**V3 - PSP-23-04**

**RE: Pearce Farm**  
**Case Number: PSP-23-04**  
**Response to 2<sup>nd</sup> PSP Review Comments**  
**AGN-23001**

PLAT MARKUPS – C2.07 Preliminary Plat and Pavement Marking Plan – Area "G"

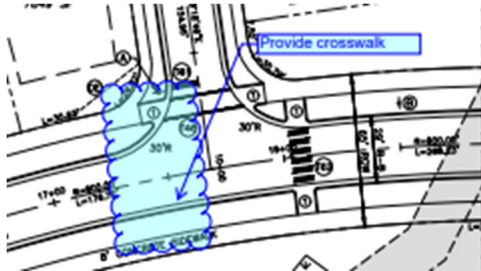
1. Please show landscape easements at the front of each lot to accommodate landscape plantings and street trees /buffer.

**McAdams Response: The 3' COR utility easement, 10' landscape buffer/easement, and 5' access, maintenance, and utility easement (alleys) have been added to all 40 scale sheets and have been labeled throughout and/or added to the legend.**

PLAT MARKUPS – C2.08 Preliminary Plat and Pavement Marking Plan – Area “H”

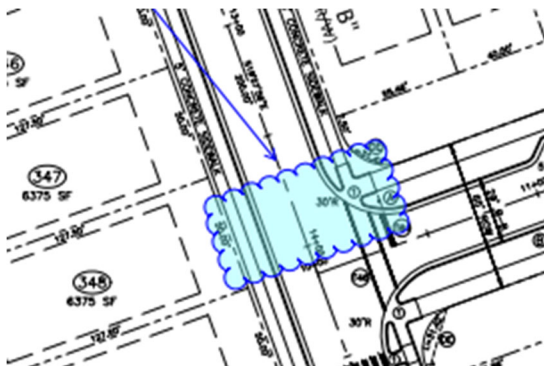
2. Consider placement of Pedestrian crossing sign so close to entrance exit of neighborhood.

**McAdams Response:** Pedestrian crossing signs have been added and labeled in this location on both sides of Street “A”.

PLAT MARKUPS – C2.09 Preliminary Plat and Pavement Marking Plan – Area “I”

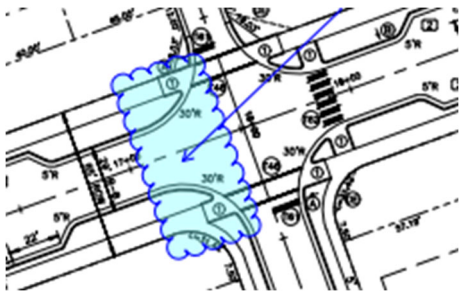
1. Provide crosswalk.

**McAdams Response:** This was discussed at the TRC meeting, and it was agreed that final crosswalk location could be determined at the time of CD production.

PLAT MARKUPS – C2.10 Preliminary Plat and Pavement Marking Plan – Area “J”

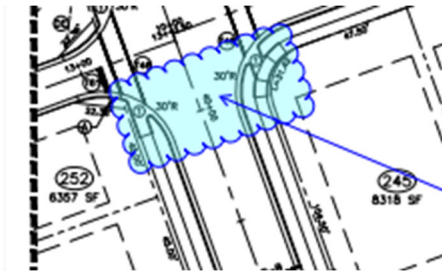
2. Provide crosswalk.

**McAdams Response:** This was discussed at the TRC meeting, and it was agreed that final crosswalk location could be determined at the time of CD production.

PLAT MARKUPS – C2.12 Preliminary Plat and Pavement Marking Plan – Area “L”

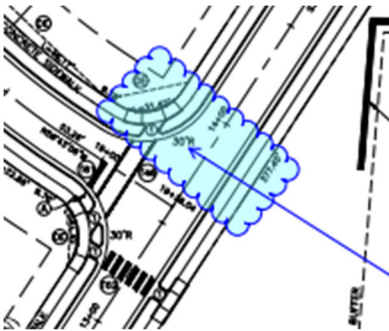
1. Provide crosswalk.

**McAdams Response:** This was discussed at the TRC meeting, and it was agreed that final crosswalk location could be determined at the time of CD production.

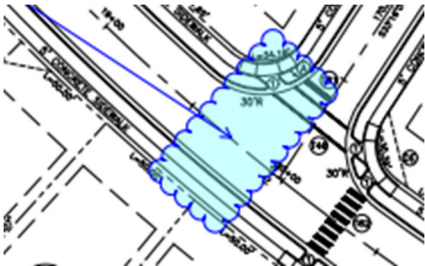
2. Provide crosswalk.

**McAdams Response:** This was discussed at the TRC meeting, and it was agreed that final crosswalk location could be determined at the time of CD production.

PLAT MARKUPS – C2.16 Preliminary Plat and Pavement Marking Plan – Area “P”

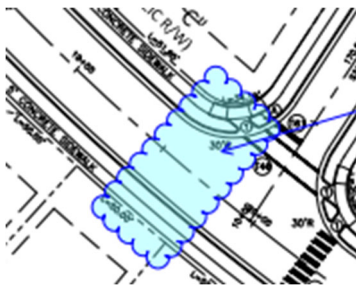
1. Provide crosswalk.

**McAdams Response:** This was discussed at the TRC meeting, and it was agreed that final crosswalk location could be determined at the time of CD production.

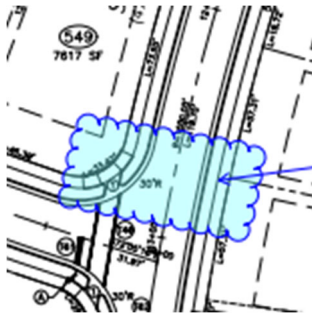
3. Provide crosswalk.

**McAdams Response:** This was discussed at the TRC meeting, and it was agreed that final crosswalk location could be determined at the time of CD production.
